# RAILROAD COMMISSION OF TEXAS

**OIL AND GAS DOCKET NO. 10-0279962**

**THE APPLICATION OF OVERFLOW ENERGY, LLC, FOR COMMERCIAL DISPOSAL  
AUTHORITY FOR THE 2124 SWD LEASE NO. 1 WELL, EMMA-JACK (GRANITE  
WASH) FIELD, HEMPHILL COUNTY, TEXAS**

**EXAMINERS' REPORT AND PROPOSAL FOR DECISION****STATEMENT OF THE CASE**

Proposed Disposal Configuration (Alternate)

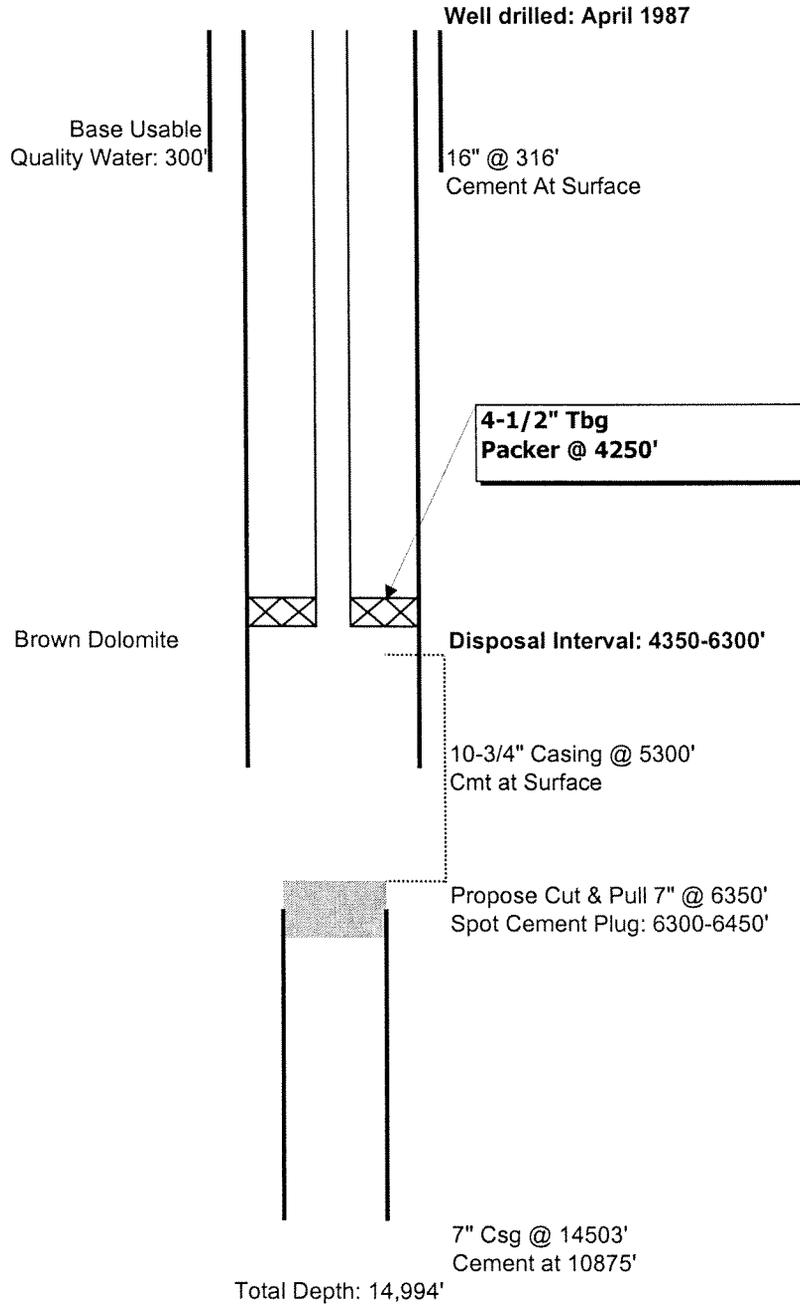
The Protestants' expert witness identified several concerns with the recompletion details for the proposed disposal well. With regards to the original proposed configuration, the Protestants were concerned that the two cement squeezes would not have adequate quality control, and especially that it would be difficult if not impossible to ascertain the efficacy of the lower squeeze at all. The Protestants reiterated that a cement squeeze should properly include a full-circle analysis and response. That is, the cement squeeze should be followed with an evaluation by cement bond log, and additional squeezes and bond logs if and as necessary to obtain and verify adequate isolation of the injection interval from the BUQW/USDW.

The Protestants were concerned that the well logs and cross section did not provide adequate evidence of 250 feet of vertical confinement between the proposed disposal interval and the BUQW/USDW. Specifically, the well log for the Harrison 1013 (the proposed 2124 SWD No. 1) was not logged (or the log was not available) above 5,200 feet. A nearby log from a depth of 3,200 was offered by the Protestants, but it did not include the evaporite interval.

The existing wellbore and casing below the disposal interval was also a concern for the Protestants. The proposal in the original configuration to perform a cement squeeze below would be difficult if not impossible to verify. The alternative configuration of setting a cement plug on top of the 7-inch casing stub would also leave several thousand feet of uncemented casing below the plug. The Protestants expressed concern about potential negative impacts to minerals below the disposal interval.

Finally, expanding the injection interval from 6,087 to 6,300 without notice was a concern to the Protestants.

Conducting a cement bond log, with additional cement squeezes if and as necessary, will ensure protection of shallow groundwater resources. Cutting and removing the 7-inch casing near the base of the disposal interval will allow for the wellbore-casing and annulus-to be adequately plugged to isolate the injection interval from lower producing intervals. Public interest claims of the applicant were not challenged.

- e. The 7-inch casing will be cut at 6,350 feet and pulled from the borehole.
  - f. The 7-inch casing stub will be plugged with cement.
  - g. The injection interval in the Panhandle Lime, Brown Dolomite and Wolfcamp formations will be from 4,350 to 6,300 feet.
